# UNITED STATES PATENT AND TRADEMARK OFFICE

<b>Office Action Summary</b>	<b>Application No.</b> 10/088,533	<b>Applicant(s)</b> CHRISTOPH ET AL.	
	<b>Examiner</b> Hoa Q. Pham	<b>Art Unit</b> 2877

## DETAILED ACTION

FIGURE 3

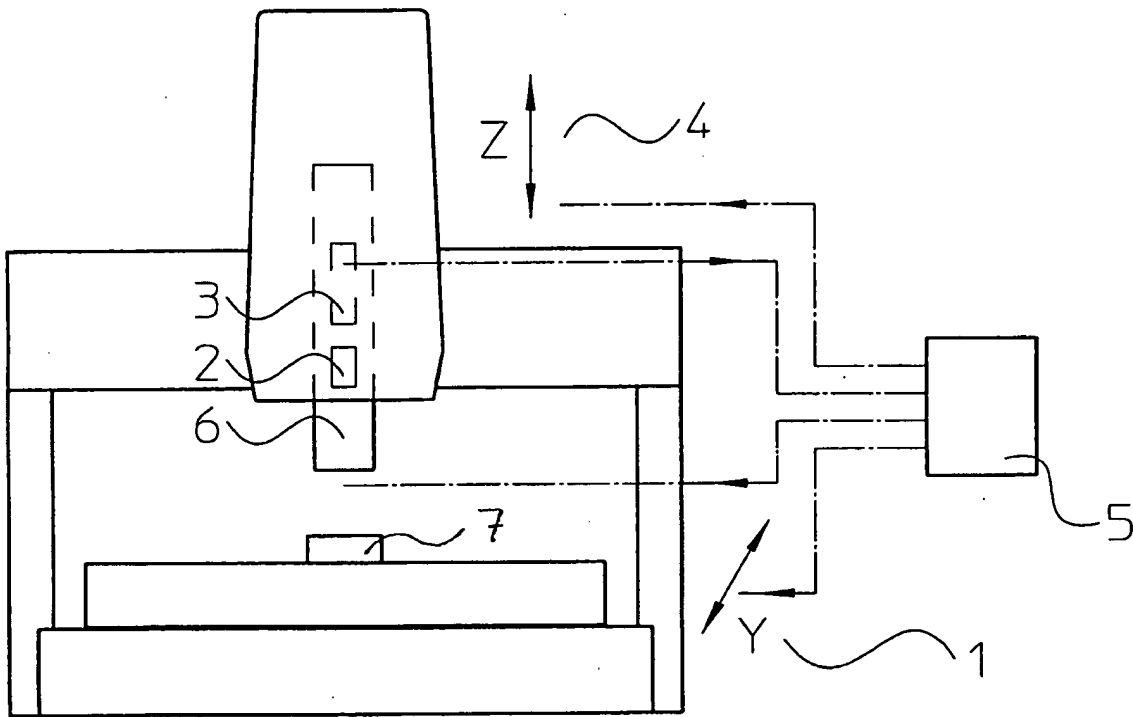
2. The drawings filed on 6/7/05 have not been entered because: (1) figure 3 has nothing to do with the drawing objection under 37 CFR 1.83 (a) and may introduce new matter to the disclosure; (2) there is no description of figure 3 in the specification; and (3) the drawing sheet must be labeled as "New Sheet" under 37 CFR 1.121 (d).

NOT ENTER!  
HP  
6/16/05
